FRIENDS of Banks Peninsula Inc.

Akaroa Treated Wastewater Options Consultation (2020)

First draft FULL SUBMISSION

Figure 2 Flow pattern with groundwater drop

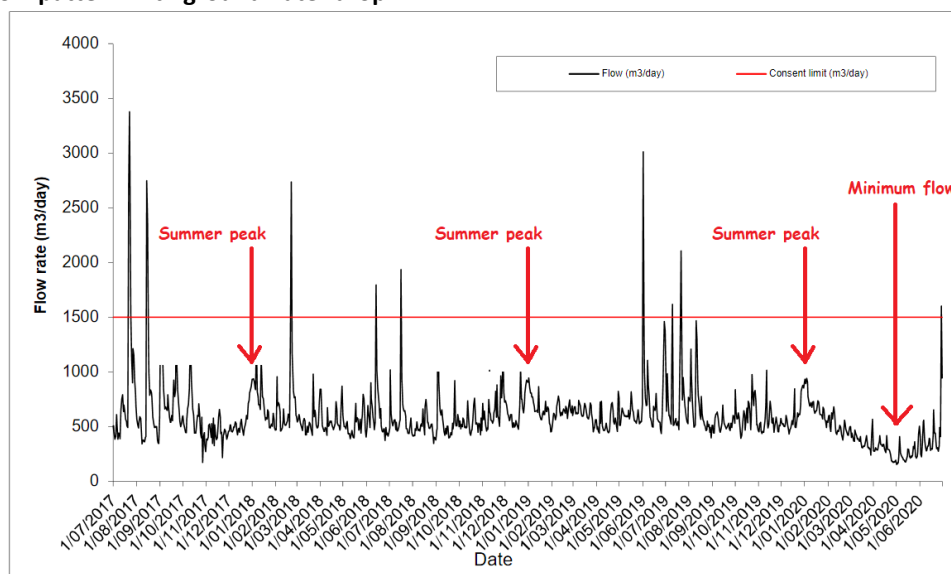
The spikes are infiltration during rainfall events. The summer sewage peaks are below 1000m³ per day and broader. The difference between the base level prior to December 2019 and the minimum point at the end of April 2020 shows the level of ground water infiltration. The decline from December 2019 to April 2020 represents the 2020 summer drought and demonstrates how ground water levels dropped. The level picks up again when it started to rain in May.

As the minimum flow point on the graph above shows, eliminating inflow and infiltration and dealing only with the real sewage would more than halve the wastewater flows and therefore the size of the system needed to deal with them. It would remove the fundamental problem that the wastewater volumes are greatest at the time when water is least needed and most difficult to get rid of.

Figure 4 Land projected to be below annual flood level in 2050 in red

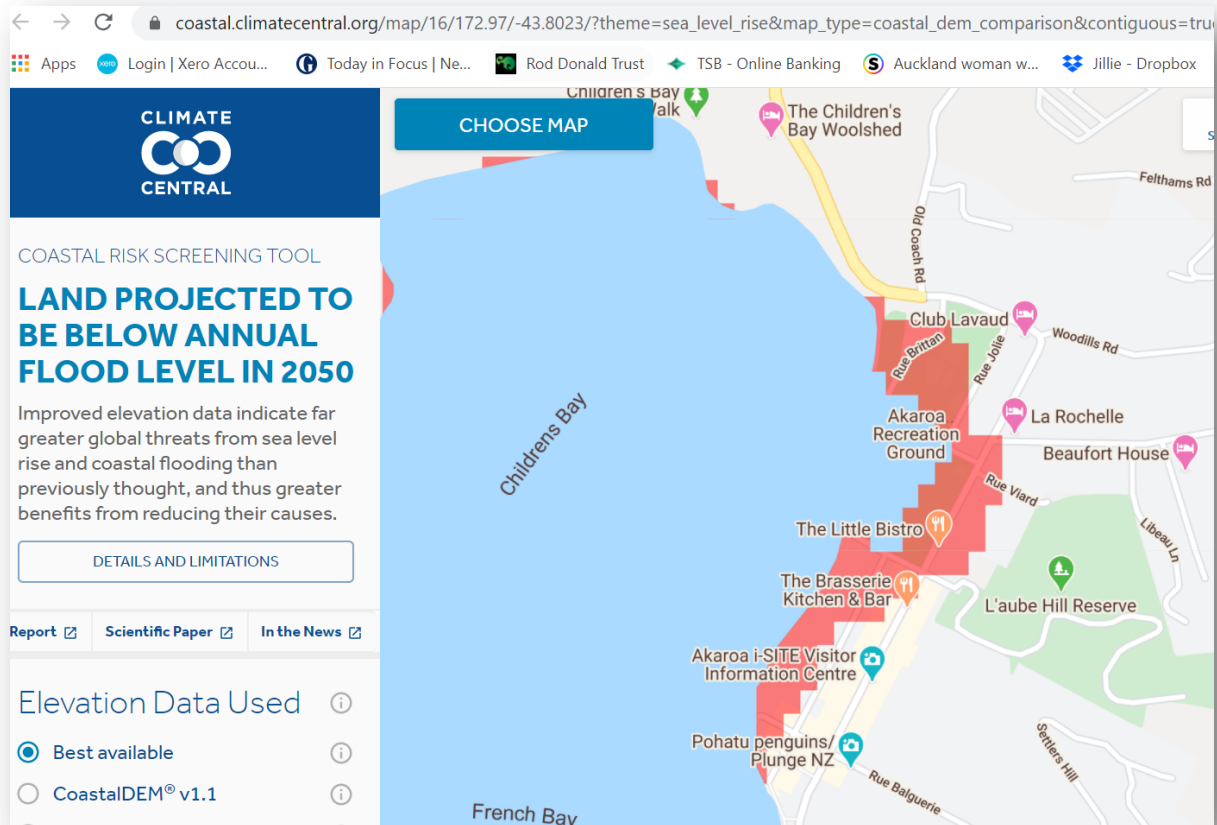
The Terminal Pump Station is located on reclaimed land on top of the former Akaroa refuse disposal site and is only slightly above sea level. The area is projected to be below the annual flood level in 2050.¹²

Figure 5 Large footprint of Inner Bays infrastructure in addition to Treatment Plant infrastructure.

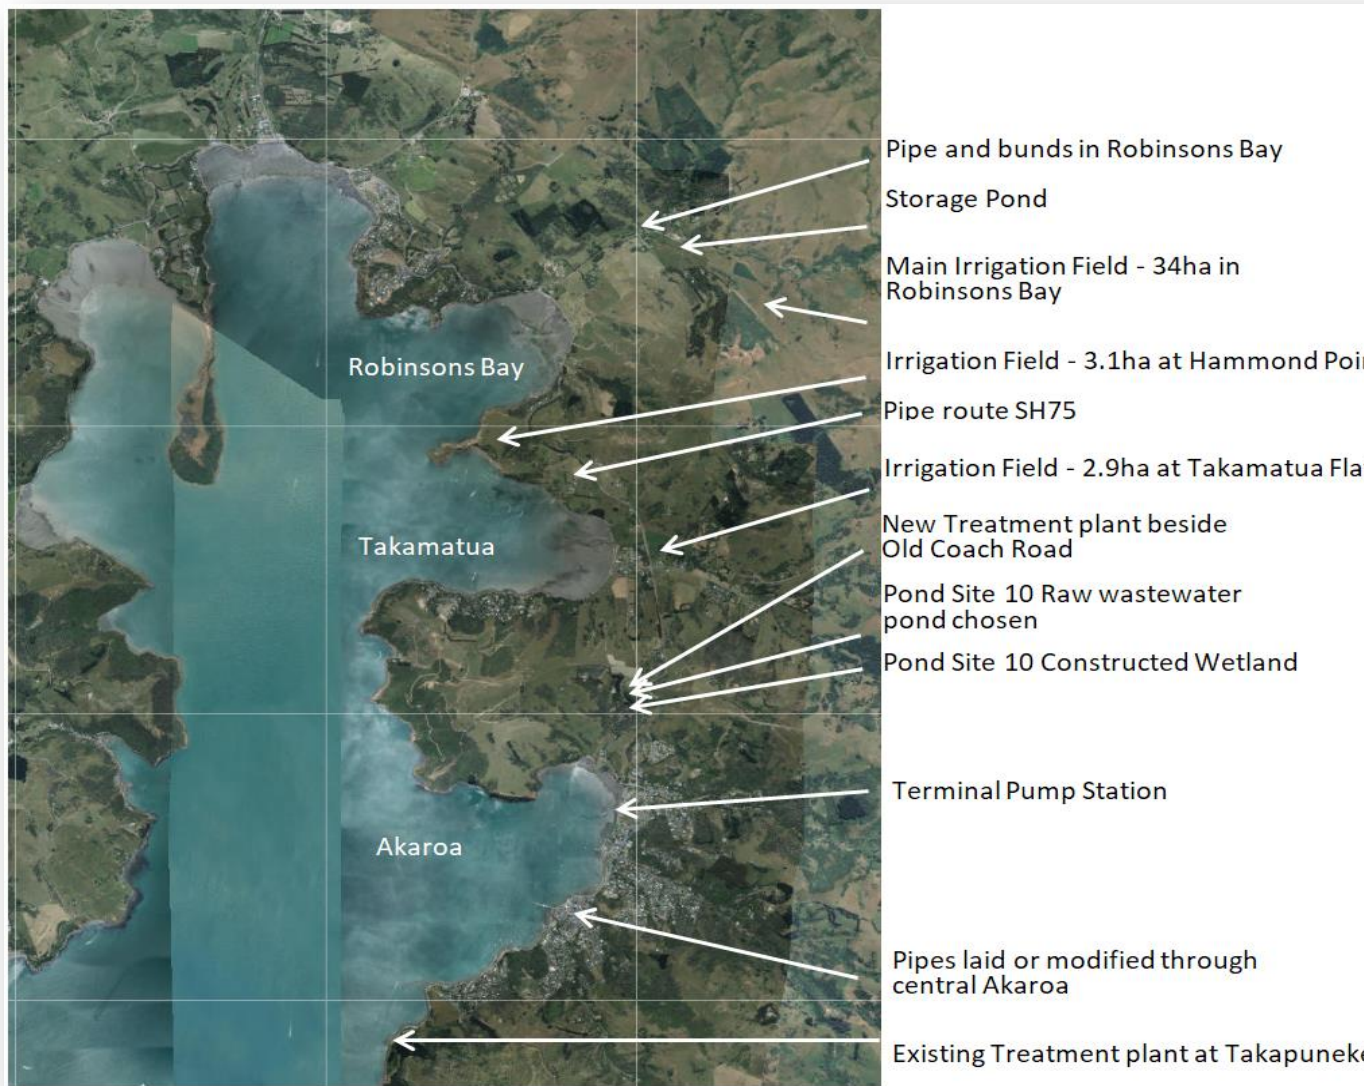
Figure 5 below shows where the Inner Bays option infrastructure would be placed in relation to the new Treatment plant.

This shows the large combined footprint of the new Treatment system with the Inner Bays option. It should be noted that the Duvauchelle scheme will add further wastewater infrastructure into the Inner Bays area on the Duvauchelle golf course and showgrounds should this also become a land based scheme.

Figure 6 Takamatua Valley site

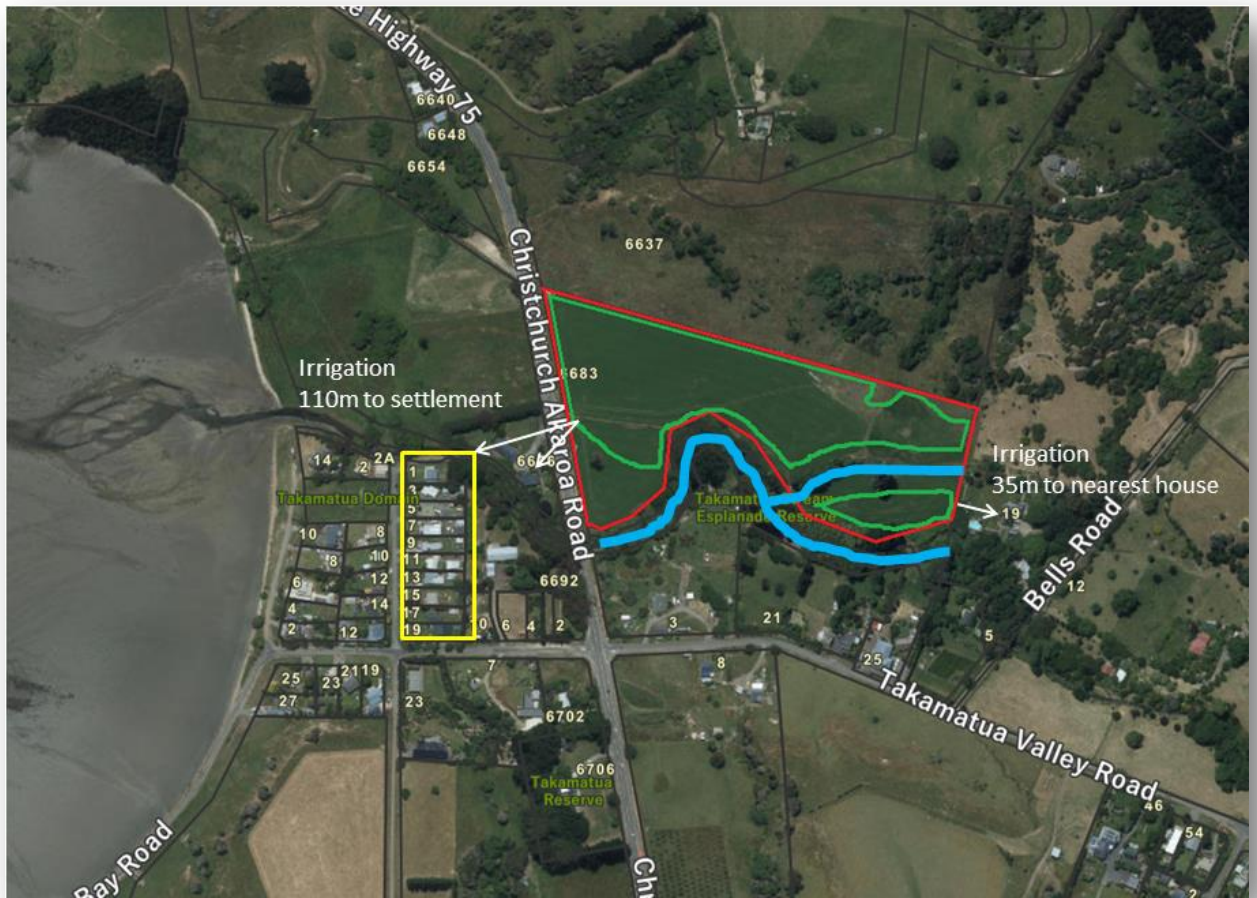
The site at Takamatua Valley is 2.9ha on the valley floor immediately to the east of the State Highway. It is low-lying and near sea level, with a stream along one boundary and houses to the east and south and a residential settlement downstream on the west side of highway.

Figure 8 Robinsons Bay site

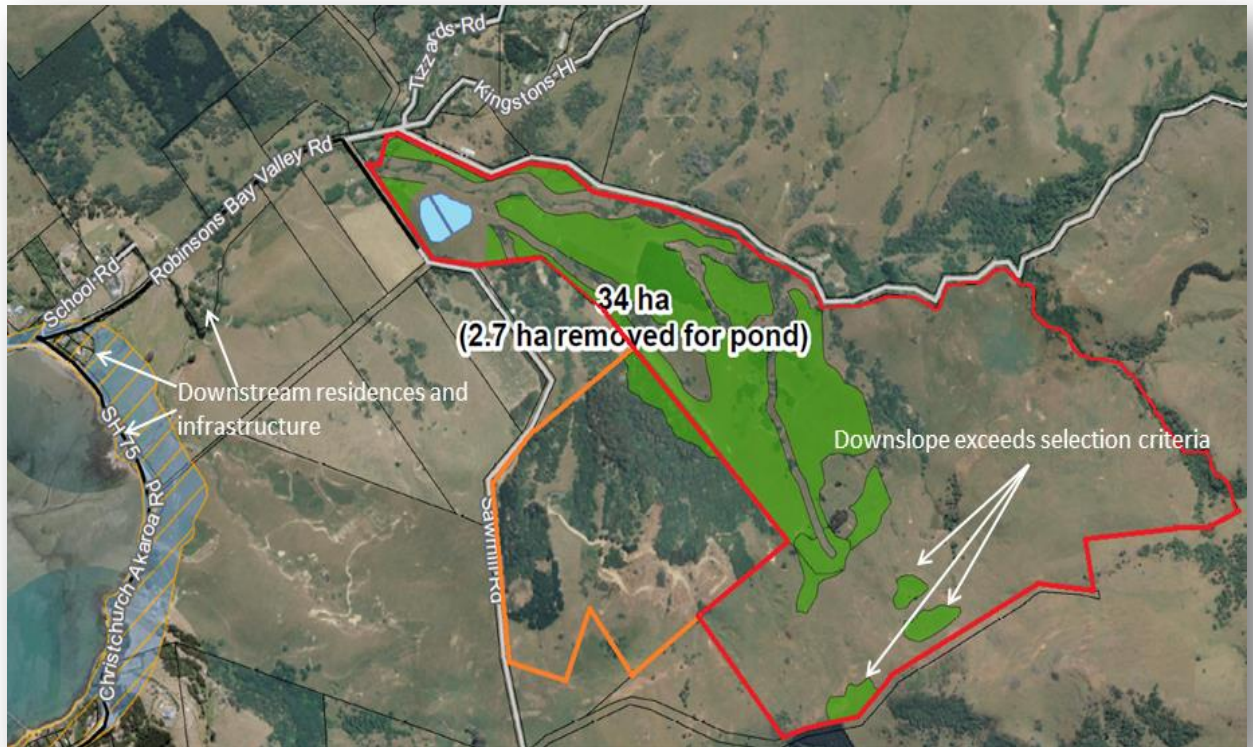
- The land in Robinsons Bay is split over two properties – the Thacker property outline in red and a small portion of the adjacent Reid property outlined in orange.
- The lower part of the Thacker block, which includes the storage pond site is surrounded by houses and contains a heritage listed site.
- There is a listed heritage building immediately below the site
- Use of the Reid property means the water supply of the property below is compromised and a new water supply will need to be sourced.

Figure 9 Storage Pond Thacker Site

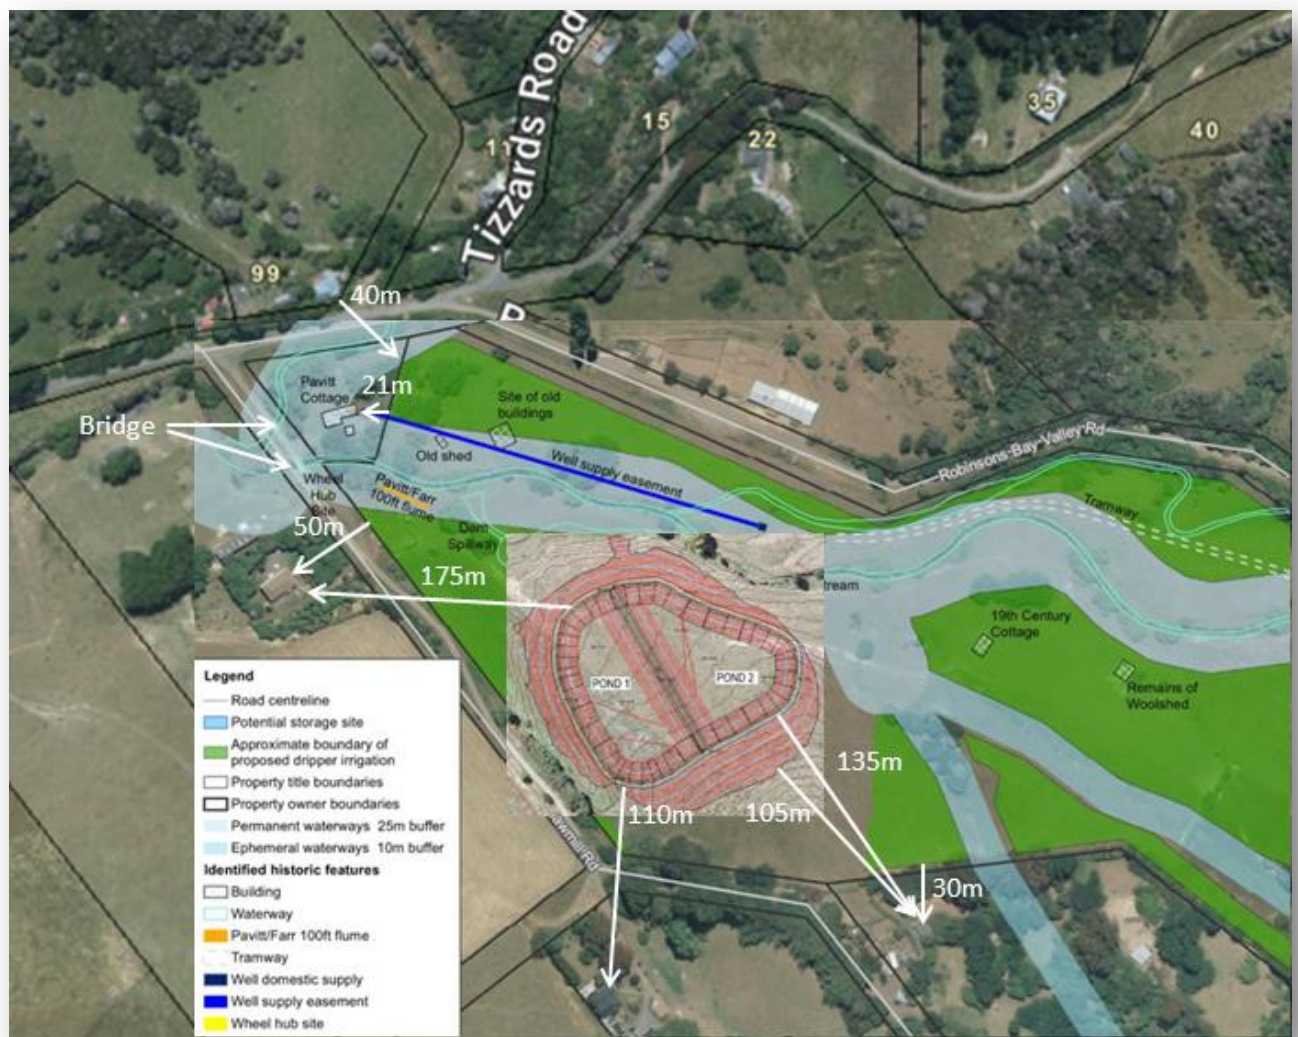
- The pond site is sandwiched between the main Robinsons Bay stream and two ephemeral streams.
- There are houses surrounding three sides of the storage pond area as indicated by the white arrows, several much closer than the 150m permitted setback in the Canterbury Air Regional Plan.³³

Figure 17 Goughs Bay Farm

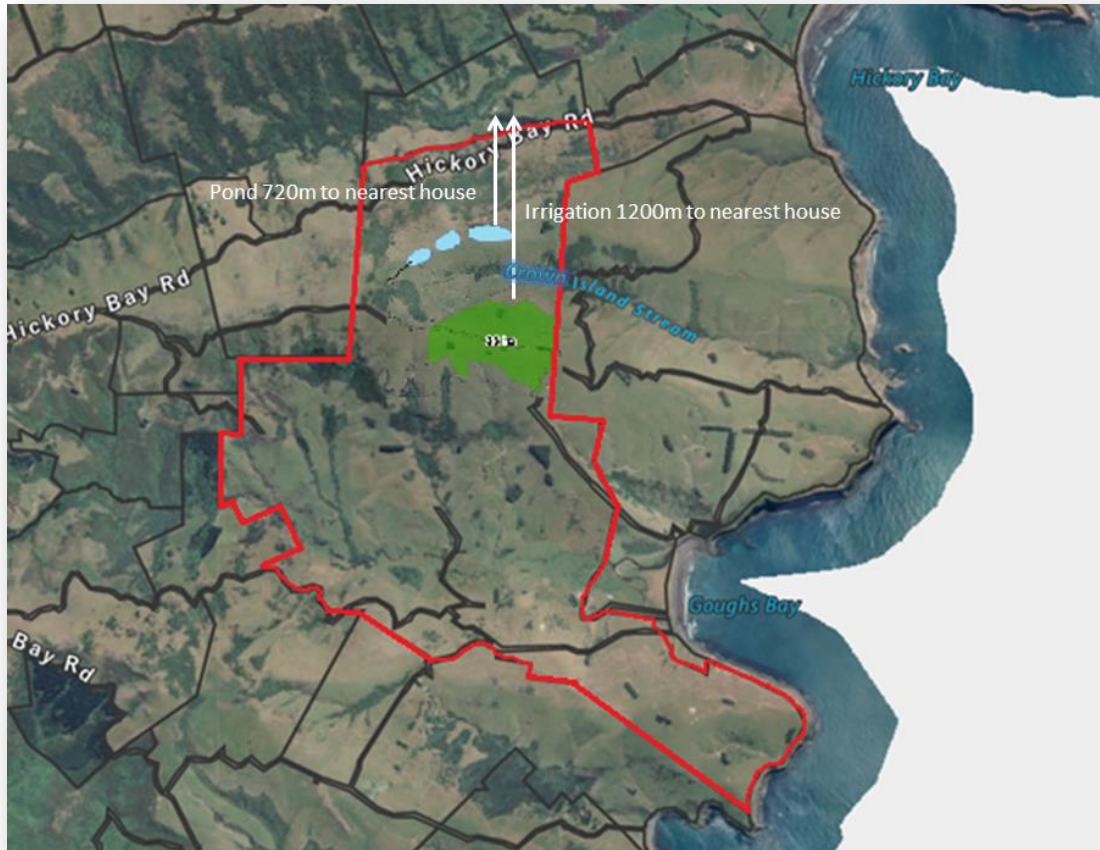
The area for the proposed irrigation system is on the headland containing the Crown Island stream. The storage ponds are on the northern side of the stream gully and the native trees would be planted on the southern side as shown in Figure 17.

Figure 18 Pompeys Pillar location

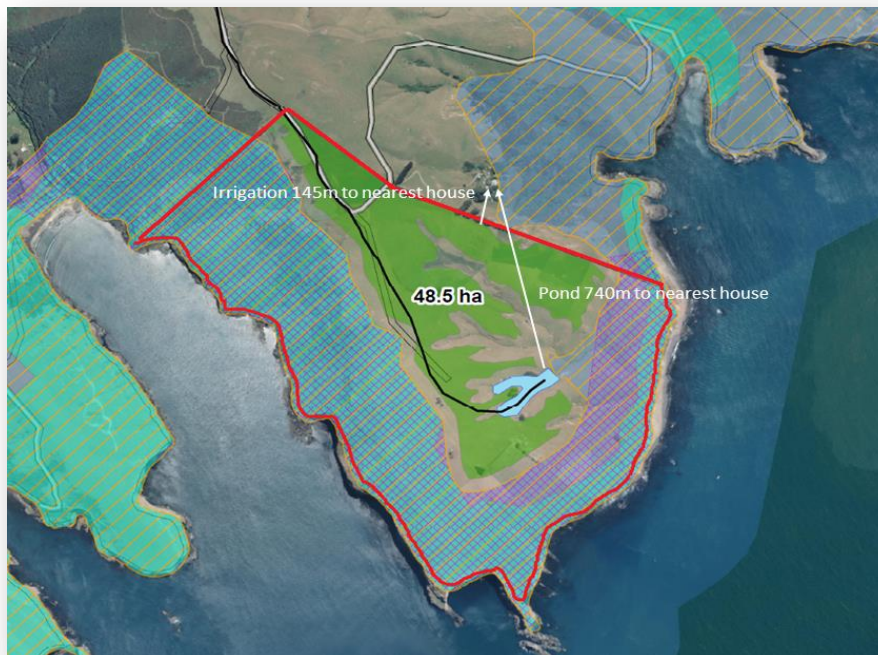
We also agree with the concerns expressed by the landowner and Wildside community that establishing native trees on the coastal and windy headland would be very difficult and they could well take many years to establish and be more stunted in form, leading to less canopy intercept.
